Work Order ID 121628

WORK ORDER NON-CONFORMANCE / UPDATE

D4462-1 BAFFLE

| C | REDESIGNED BAFFLES TO ALLOW RIVETING TO SIDE WALLS. ADDED NOTE 8 ON SHEET 2 & 4 (ZN A8-6) | ML | 14.05.13 |
|------------|--|--|----------|
| DESIGN | ML | DART AEROSPACE LTD HAWKESBURY, ONTARIO, CANADA DRAWING NO. D4462 TITLE BAFFLE SCALE NTS COPYRIGHT © 2011 BY DART AEROSPACE LTD <small>THIS DOCUMENT IS PRIVATE AND CONFIDENTIAL AND IS SUPPLIED ON THE EXPRESS CONDITION THAT IT IS NOT TO BE USED FOR ANY PURPOSE OR COPIED OR COMMUNICATED TO ANY OTHER PERSON WITHOUT WRITTEN PERMISSION FROM DART AEROSPACE LTD.</small> | |

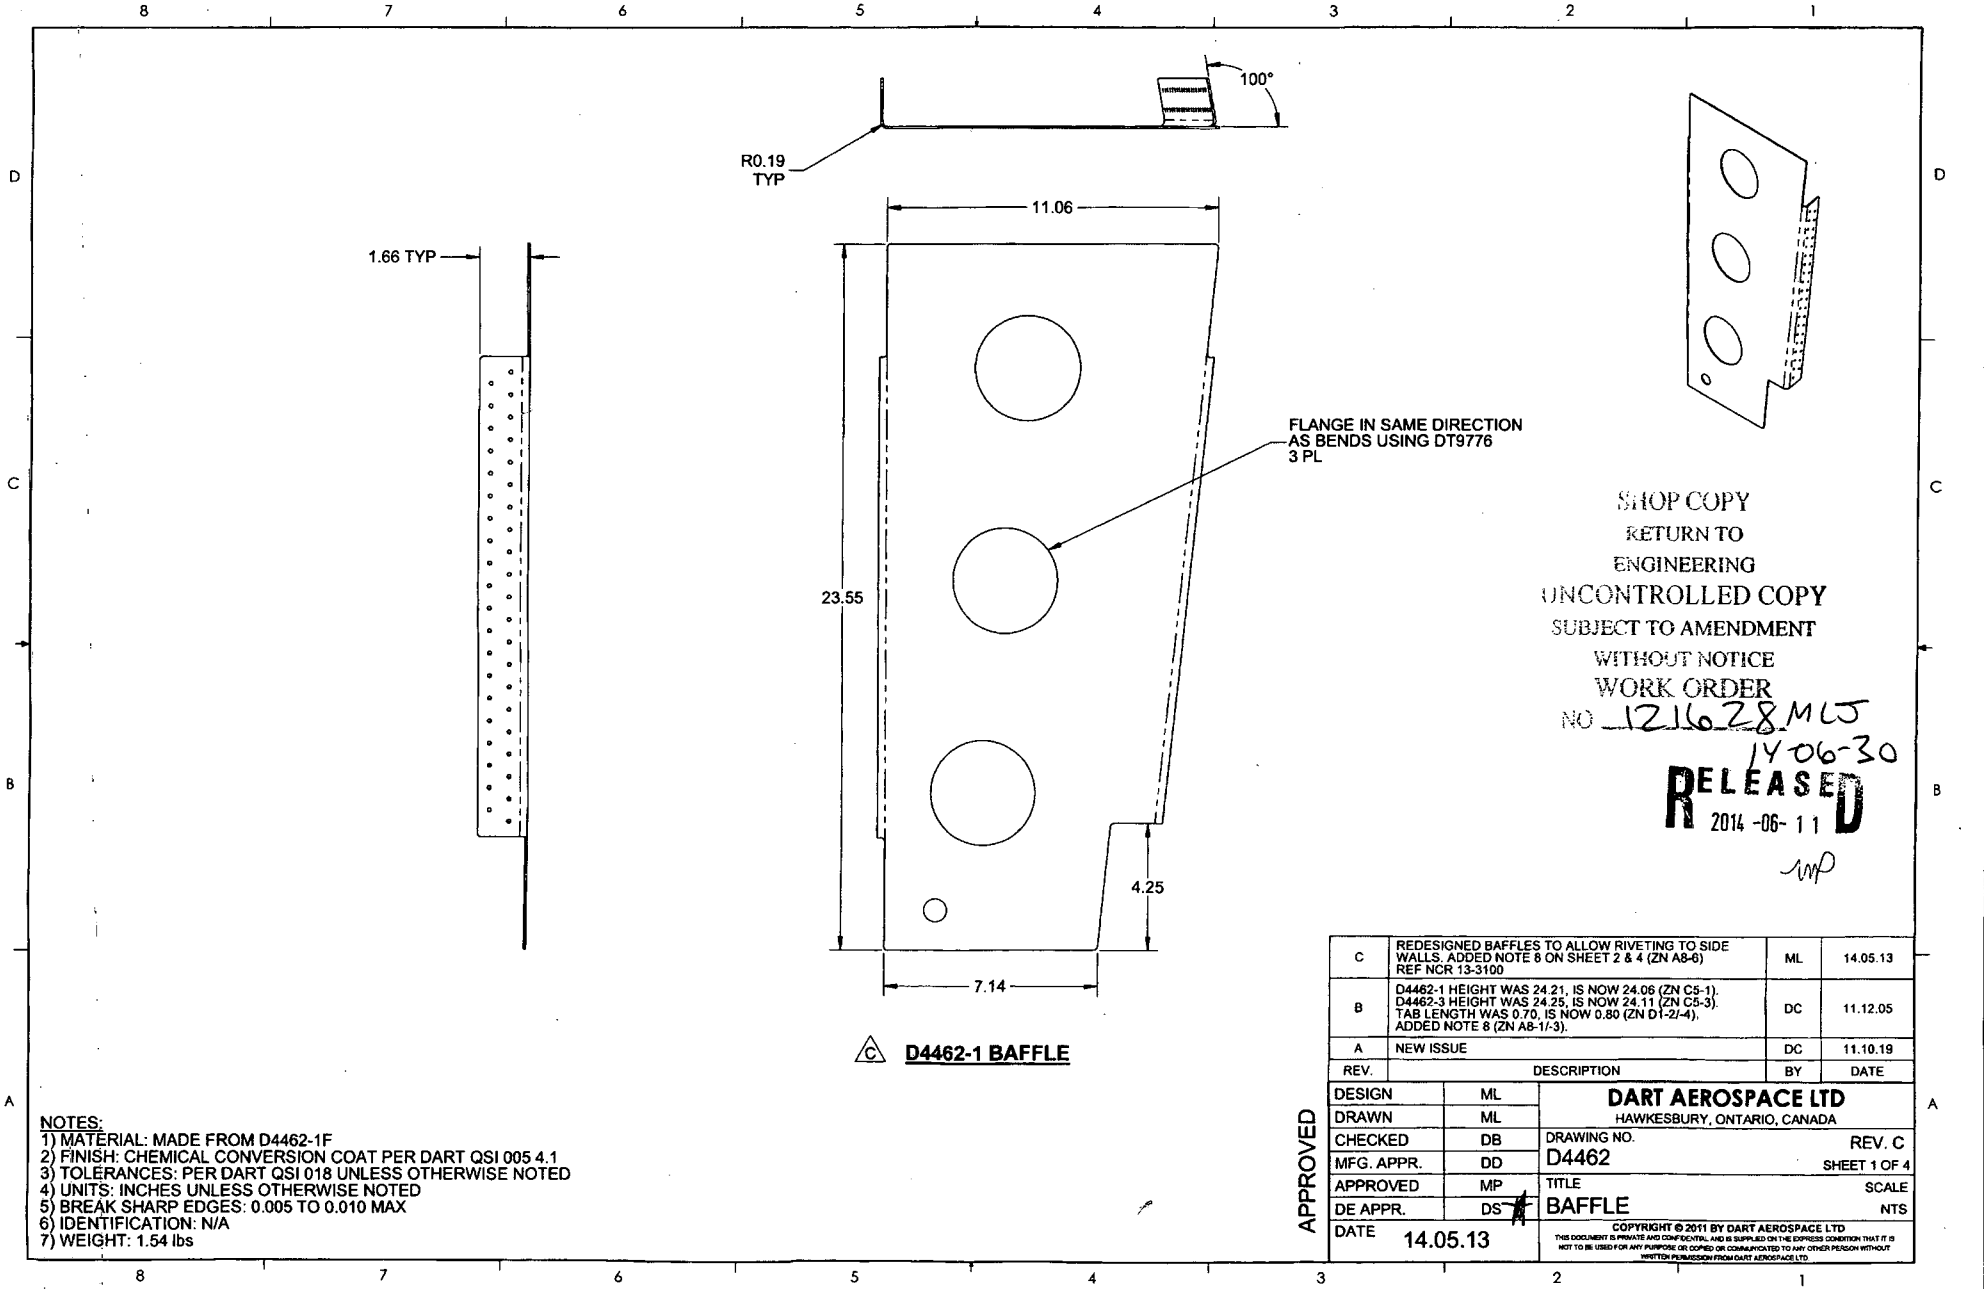
| Root Cause | Date | Step | Qty | Description of work order update or non-conformance | Initial Chief Eng | Action Description | Sign & Date | Verification | QC Inspector |
|---------------|-------------------------------------|------|-----|--|-------------------|--|-------------|--------------|---------------------|
| Design | 14/7/23 | 100 | 1 | Ø 1/8 rivet holes are undersized / over sized / out-of-round due to water jet. | DAS 12 9-89 | Oversize holes to Drill #20 (Ø0.161). Use next size rivet when assembling. | mm 14/07/23 | QB 14/07/23 | DAS 27 9-89 14/7/23 |
